Ser. No. 10/519,028  
Amtd. dated November 14, 2008  
Reply to Office action of June 30, 2008

**Amendments to the Drawings**

METHOD AND SYSTEM FOR DETECTING AND PERFORMING  
 Michael Dwayne Kuhn  
 10/519 028

FIG. 1

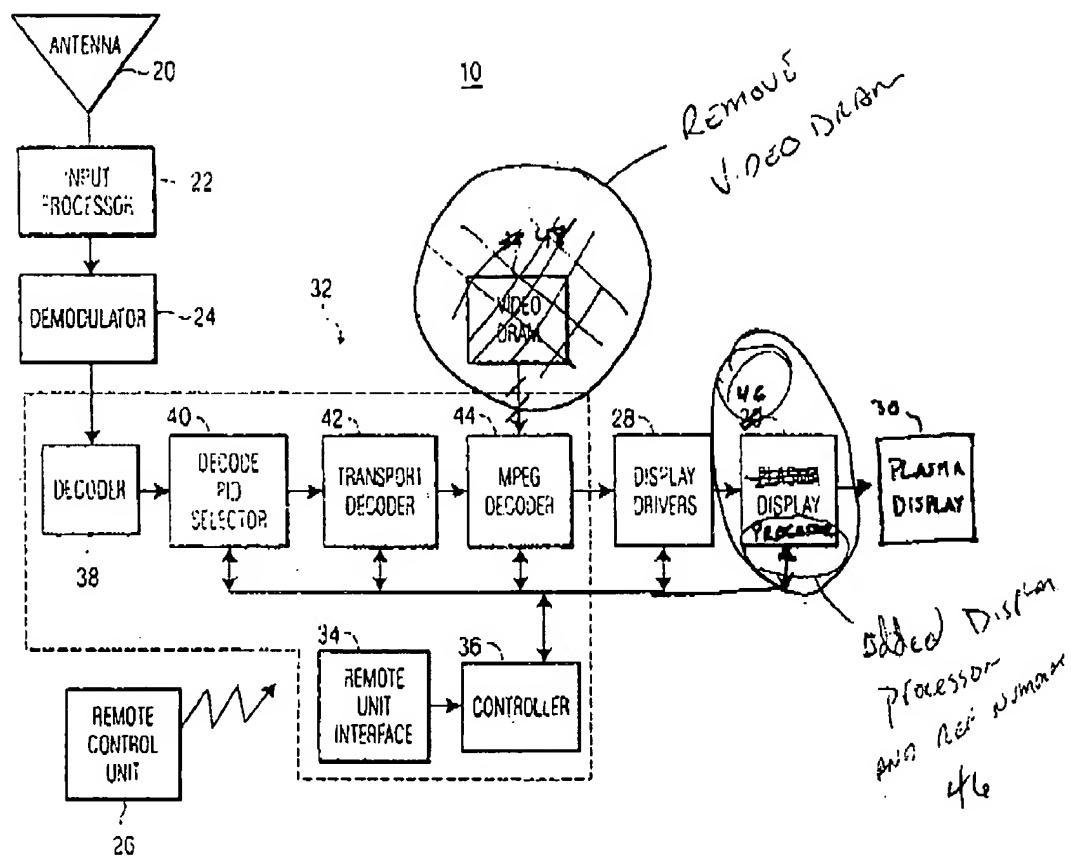
The attached sheets of drawings include changes to Figs. 1-2. These sheets, which include Figs. 1-2, replace the previously filed replacement sheets including Figs. 1-2. In Figure 1, previously omitted element 46, described on page 7 of the specification, has been added and the duplicate use of label 44 has been corrected. In Figure 2, previously omitted element labels 61 and 69 have been added.
